**Pacific Gas and
Electric Company®**

PG&E Letter DCL-10-082

Diablo Canyon Units 1 and 2

Response to NRC Letter dated July 6, 2010, Request for Additional Information for
the Applicant's Environmental Report - Operating License Renewal Stage

Figure 15 - DCPP 10-Meter Level Wind Rose for 1981-82 (Before Simulator Building)

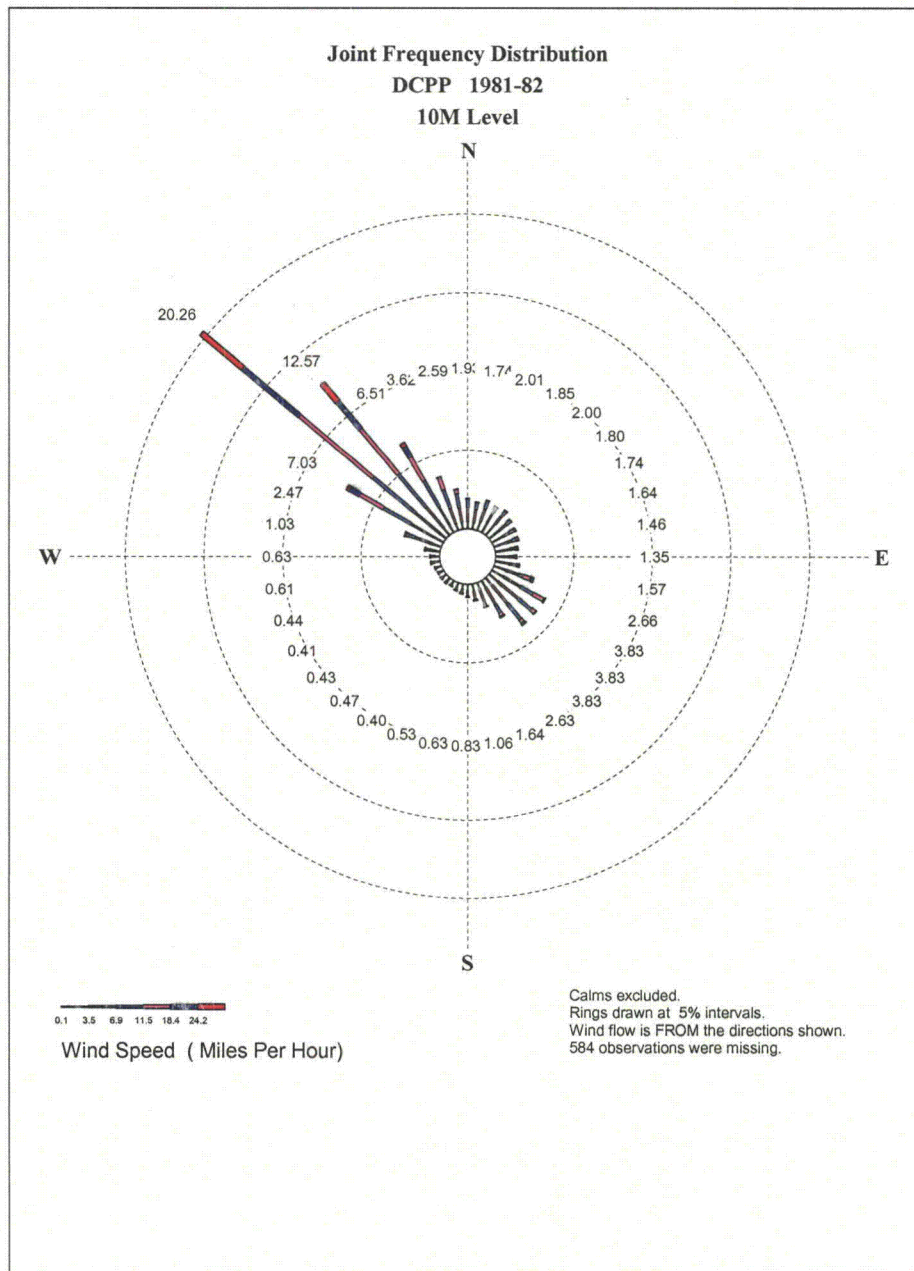
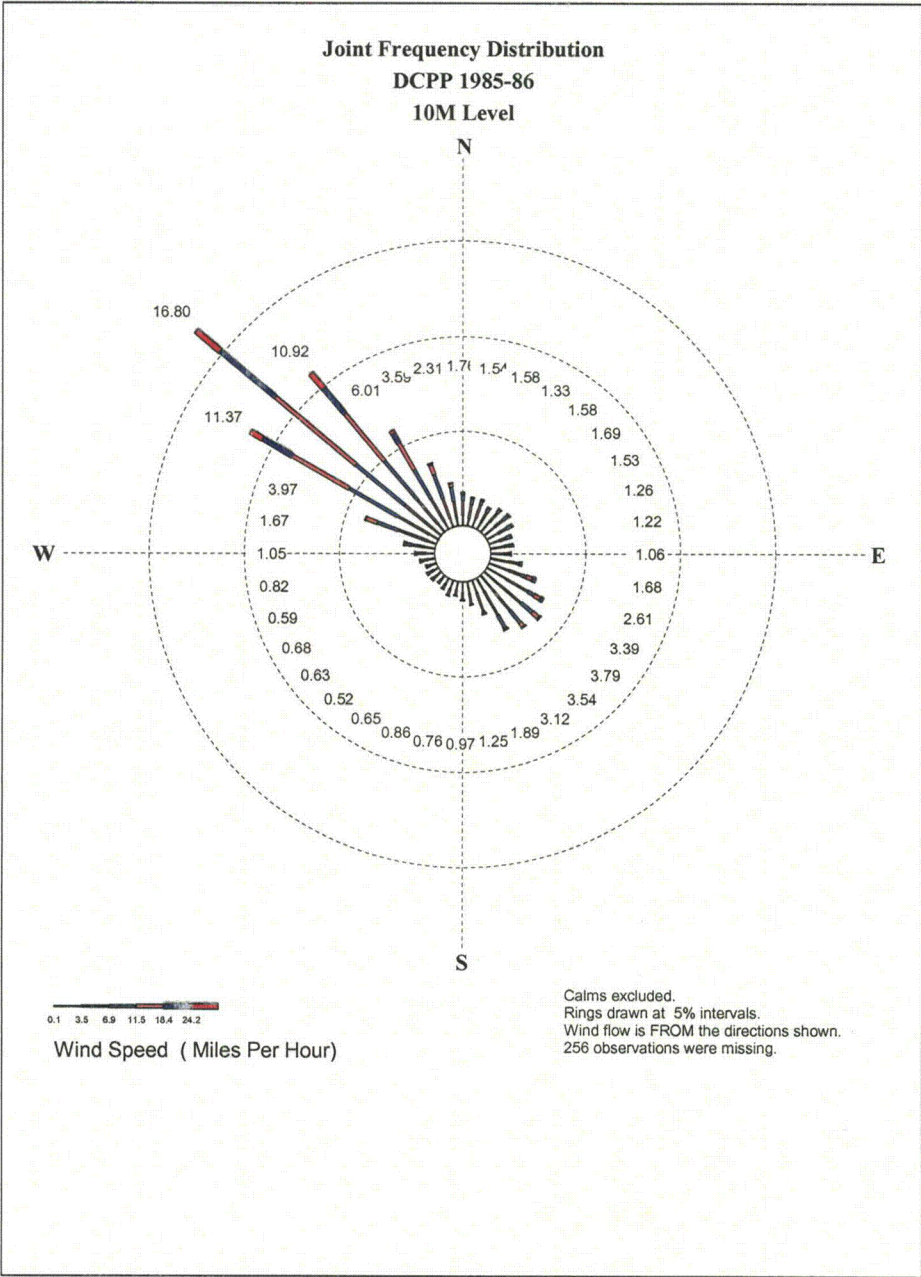
Regulatory Guide 1.23, Revision 1 states that "Whenever possible, wind measurements should be made at locations and heights that avoid airflow modifications by obstructions such as large structures, trees, and nearby terrain. The sensors should be located over level, open terrain at a distance of at least 10 times the height of any nearby obstruction if the height of the obstruction exceeds one-half the height of the wind measurement." During the Diablo Canyon Site Audit, the NRC meteorology reviewer noted that the onsite meteorological tower is within 250 feet of the Simulator building. Given that the building height is about 35 feet – approximately the same elevation as the 10 meter wind speed sensor – its proximity to the meteorological tower could influence the wind speed and direction data used in the SAMA analysis. The meteorological tower is also located within an asphalt parking lot, which could potentially affect the stability classification under certain meteorological conditions (e.g., sunny days with low windspeed). Justify that the meteorological data used in the SAMA analysis (collected at 10 meters) are high quality data representative of the Diablo Canyon site and are not adversely affected by the siting of the meteorological tower.

The data for calendar years 1981 and 1982 were combined into one file; the data for calendar years 1985 and 1986 were also combined into one file. Two new wind roses, multi-year wind roses using 36 sectors rather than 16 sectors, were created to provide additional detail on the wind rose before and after simulator building construction. These two wind roses are presented in Figures 15 and 16.

In Figure 15, the period prior to simulator building construction is examined. Wind directions centered on 70, 80, 90, 100, and 110 degrees occurred 1.54, 1.46, 1.35, 1.57, and 2.66 percent of the time.

In Figure 16, the 2-year period after the simulator building is completed, wind directions centered on 70, 80, 90, 100, and 110 degrees occurred 1.26, 1.22, 1.06, 1.68, and 2.61 percent of the time.

It appears that there are no significant differences between the wind roses for these two periods.
